Sheet: /16x2-4 LCD Display/
File: lcddisplay.kicad_sch

Sheet: /Audio Codec/
 File: audioic.kicad_sch

Sheet: /Control Debug Keys and Internal Neopixels/
File: debugdispcontrol.kicad_sch

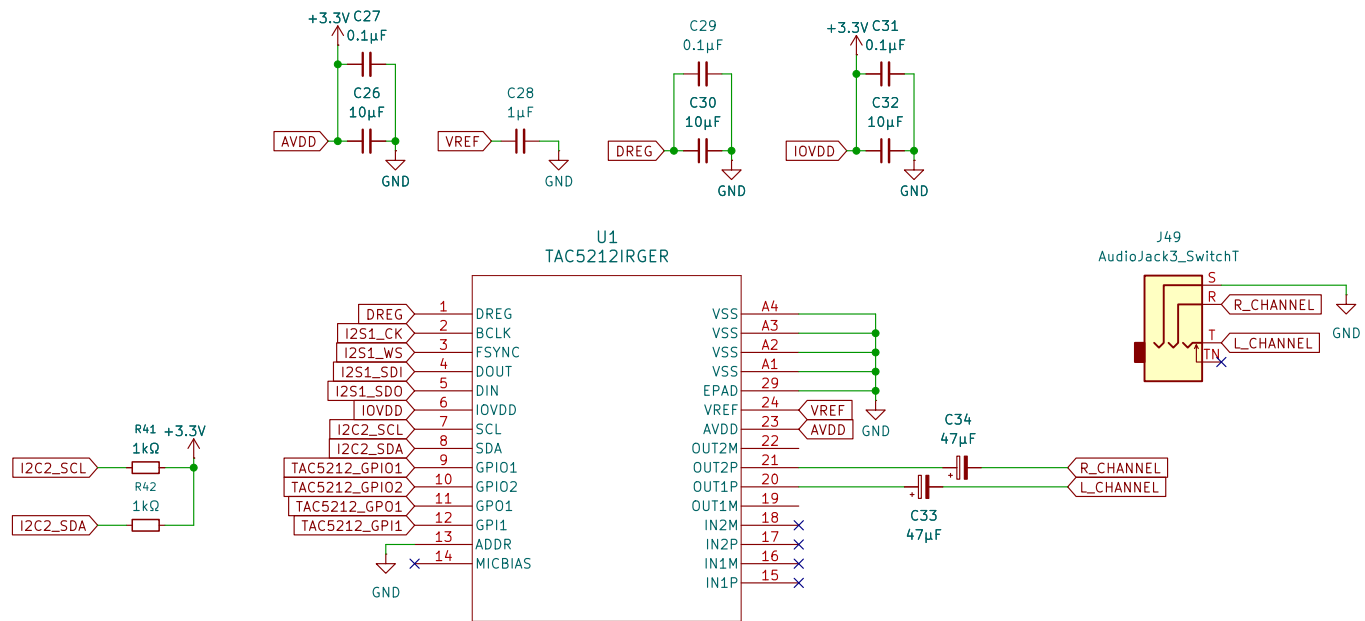
5v power is supplied to the i2c lcd display

it is expected there's support for 3v3 logic on i2c!!!!
(meaning no 5v pullups on the device side)
(if so, level shifters needed)
(if not present, the board is fried)

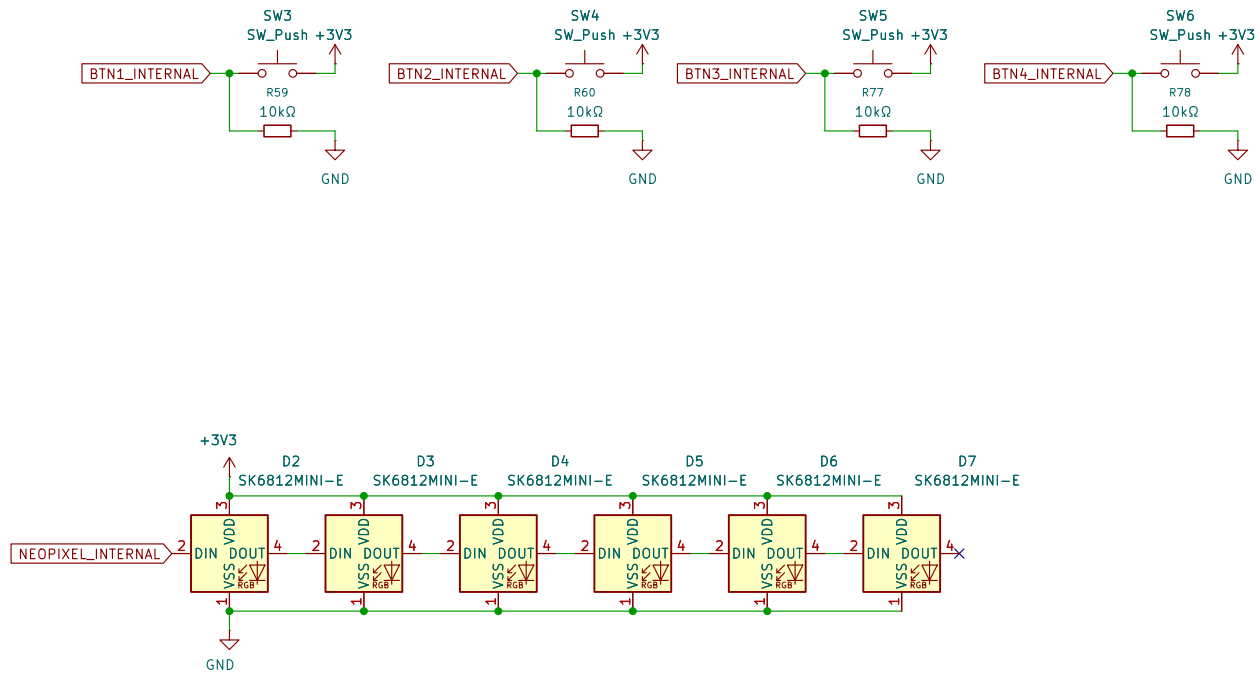
maybe add decoupling caps
